Global Forum for Road Traffic Safety**Group of Experts on Road Signs and Signals****Fifteenth-session**

Report of the Group of Experts on Road Signs and Signals on its fifteenth session**I. Attendance**

A sign-by-sign assessment by the Group of Experts

A, 20 “INTERSECTION WITH A ROAD TO WHOSE USERS DRIVERS MUST GIVE WAY”

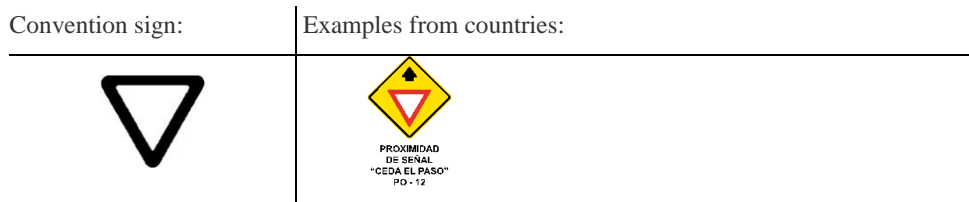
The Group noted that only a very few countries use the sign A, 20 while the majority of countries use the sign B, 1 with additional panel H, 1. This second possibility is introduced with paragraph 6 Article 10 (first sentence). However, the Group noted that both the paragraph 6 as well as point 20 (a) of Section A of Annex 1 require that the same warning is implemented by different signs both being obligatory.

The Group recommended the following amendment to point 20 (a) while removing the sign A, 20:

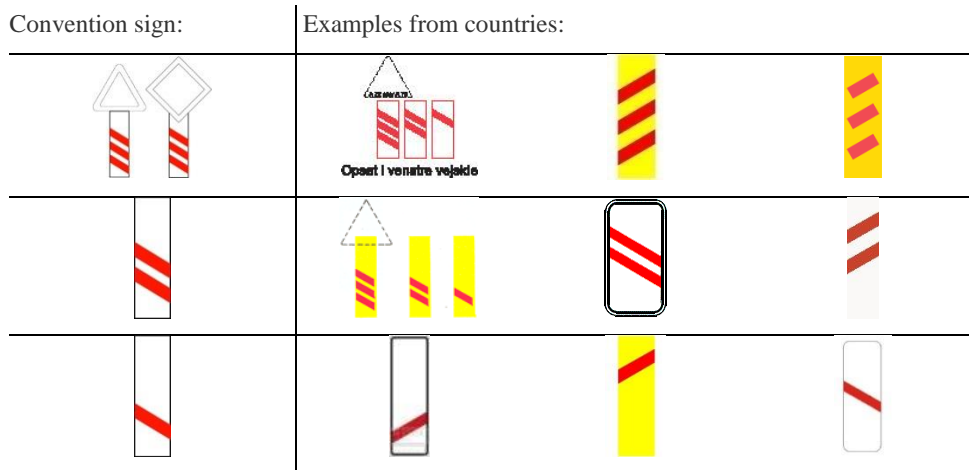
The Group noted that one country (Sweden) uses the panel that appears not to be in conformity with the Convention.

The Group recommended to reproduce the images of signs for both sides of the carriageway.

The Group believes, in terms of visibility, that the bars (one, two or three) be placed in the upper part of the panels (ref. to the sign from Finland) or preferably centred on the panels. The Group recommended including the preferred variant on the images reproduced in the Convention.

The Group further recommended to amend the text of the Convention Annex I, Section A, II Description, point 29 as follows:

B, 1 "GIVE WAY"

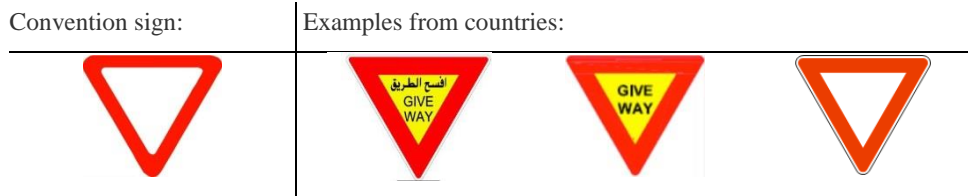
The Group noted that some countries included the text "Give way" within the sign. The Group noted that, for the countries wishing to include the text "Give way", there is the possibility that this could be done in an additional panel or within the sign itself (Article 8, paragraph 3).

The Group proposed to revise the provisions related to B, 1 sign, as follows:

B, 4 “END OF PRIORITY”

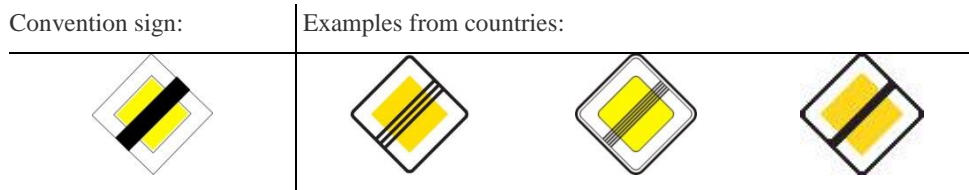
The Group noted that some countries do not use the black narrow strip for the yellow or orange square in the centre, and recommended that they do so. The Group further recommend that the orange colour option for inside square be removed.

The Group recommended to amend the definition of sign B, 4 as follows:

B, 5 "PRIORITY FOR ONCOMING TRAFFIC"

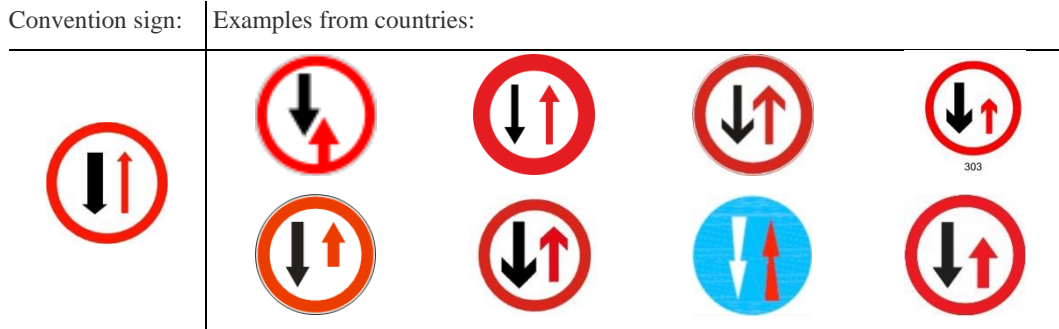
The Group noted that some countries do not use the arrows (i.e. length, width, positioning) as they appear in the Convention. The Group recommended that the arrowheads in the symbol used in Annex 3 of the Convention be enlarged and that the arrows are of the same width. The Group also recommended that the following additional words be inserted at the start of the article related to sign B, 5: "The sign indicating priority for oncoming traffic shall be sign B, 5." The Group further agreed that an alternative design option should be added for this sign following the Lithuanian example.

B, 6 "PRIORITY OVER ONCOMING TRAFFIC"

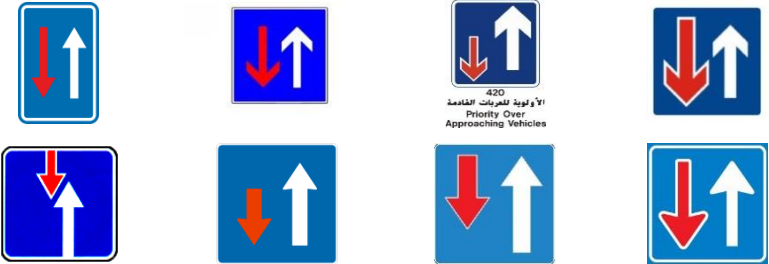
The Group noted that some countries do not use the arrows (i.e. length, width, positioning) as they appear in the Convention. The Group recommended that the arrowheads in the symbol used in Annex 3 of the Convention be enlarged, and that the arrows are of the same width. The Group also recommended that the following additional words be inserted at the start of the article related to sign B, 6: "The sign indicating priority over oncoming traffic shall be sign B, 6." To assist colour-blind drivers, the Group recommended that a white narrow strip should be inserted around the red arrow. The Group further agreed that an alternative design option should be added for this sign following the Lithuanian example.

C, 8 “NO ENTRY FOR VEHICLES HAVING A MASS EXCEEDING ... TONNES ON ONE AXLE”

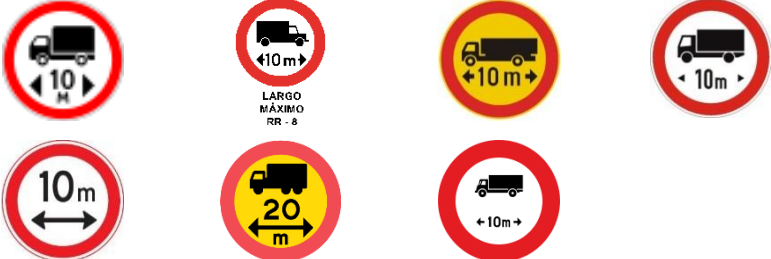
The Group noted that there was a difference in the casing of the symbol “T” (i.e. some countries use lower casing “t”), its positioning within the sign, and also that some countries used commas and period marks. The Group also noted differences in the arrowheads and axles. The Group believed that the symbol in the Convention should be modified from upper to lower casing (“t”) and that the positioning of the symbol “t” should appear where it currently appears in the Convention. The group also believed that the arrow should be deleted, replaced by one arrowhead and that the number used for the first digit in the Convention symbol should be larger.

Finally, the Group believed, that where a comma or period mark is used, that the second digit should be two-thirds the size of the first digit, and that the lower casing “t” should appear immediately after the second digit and at the same level, and be proportionately visible. If a fraction is required, the Group believed that it should be to the nearest tenth (i.e. 3.5t, 7.8t). If it is an integer (i.e. 7.00t), it should appear without any zeros or period marks (i.e. 7t).

E, 1 c “SPEED LIMITS APPLYING TO DIFFERENT LANES”

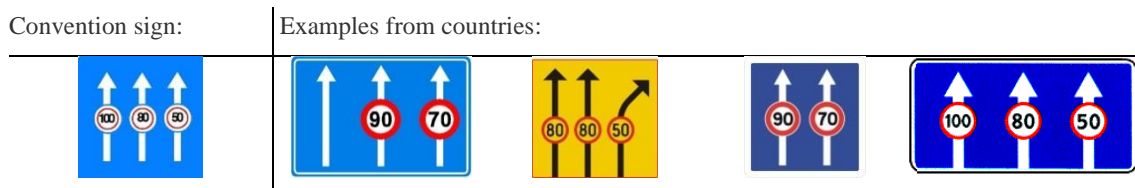
Azerbaijan used a wrong example for E, 1 c sign (truck entry prohibition sign instead of speed limit sign).

The Group recommended that the E, 1 c sign is improved by placing the sign C, 14 on the arrows and adding a white rim.

E, 2 a “SIGNS INDICATING LANES RESERVED FOR BUSES”

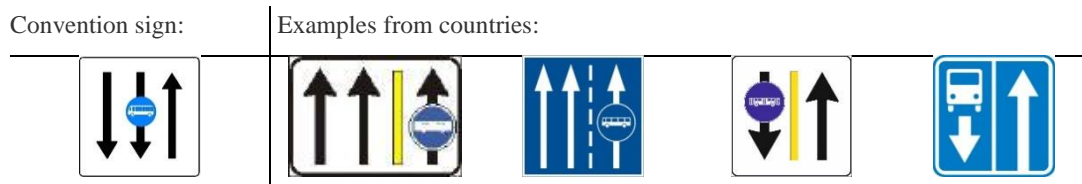
Article 26bis paragraph 2, Section E, sub-section II, point 2 and E, 2 a and E, 2 b reproductions in Annex 3 do not appear to be consistent and thus do not clearly define signs E, 2 a and E, 2 b.

Several countries (Azerbaijan, Belgium, Croatia, Latvia, Luxembourg, Montenegro and Ukraine) use examples for E, 2 a that do not correspond to the examples of the Convention.

Many countries use road markings (broken or continuous line) on this sign. The Group recommended the symbols on this sign not to include road markings as the arrows indicate the “lanes”.

F, 16 “BEACH OR SWIMMING POOL”

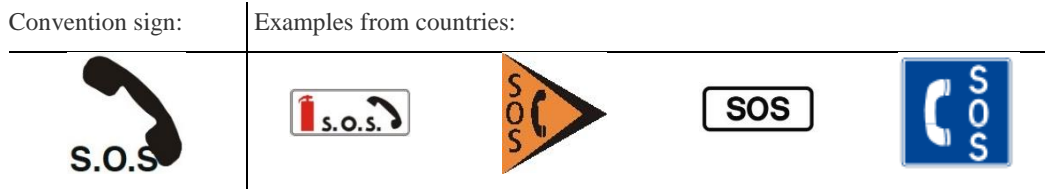
The Group recommended that the sign be removed from the European Agreement.

G, 2a and G, 2b “NO THROUGH ROAD” (advance direction signs)

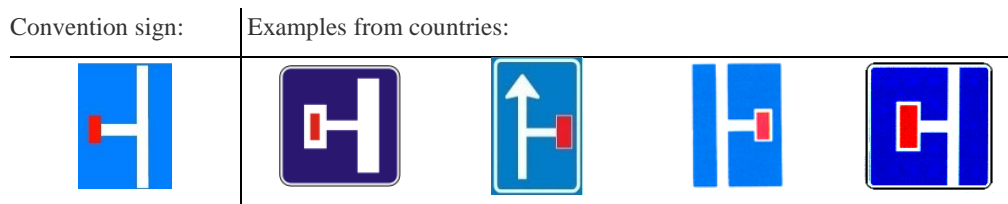
The Group noted that Belgium inserted sign G, 13 into RSMS for both signs, and Latvia inserted G, 13 for G, 2a.

The Group also noted that the G, 2a Slovakian sign had a white border, instead of a rim, around the red bar. The Group further noted that the G, 2a sign from the Netherlands contained an arrow. The Group considered these signs not to be in conformity with the Convention.

The Group noted that, in the G, 2a signs of some countries (Azerbaijan, Greece, Lithuania, Republic of Moldova, Russian Federation, Ukraine, Uzbekistan and Viet Nam), and in the G, 2b sign of Greece, there was no visible space between the symbol and the edge of the sign. The Group believed that this was not a good practice for sign legibility.

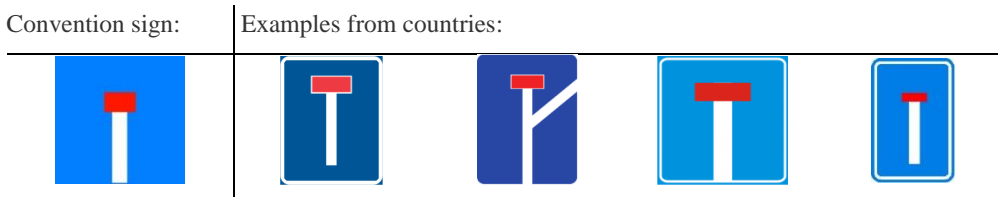
The Group of Experts noted that a few countries had inserted variants of the G, 13 sign or the incorrect sign into the RSMS. It was of the view that the correct signs should replace the incorrect signs.

The Group also noted that a number of countries did not have the white part of the symbol going to the bottom edge of the sign.

The Group also noted that a white narrow strip around the red bar was mandatory for Contracting Parties to the 1971 European Agreement. In this regard, a few countries were not in conformity.

The Group was of the view that with regards to the Convention sign, there was insufficient space between the symbol and the bottom edge of the sign. The Group believed that this was not a good practice for sign legibility. It recommended that a white narrow strip be placed around the red bar.

The Group recommended the following amendment to the provision for the G, 13 sign:
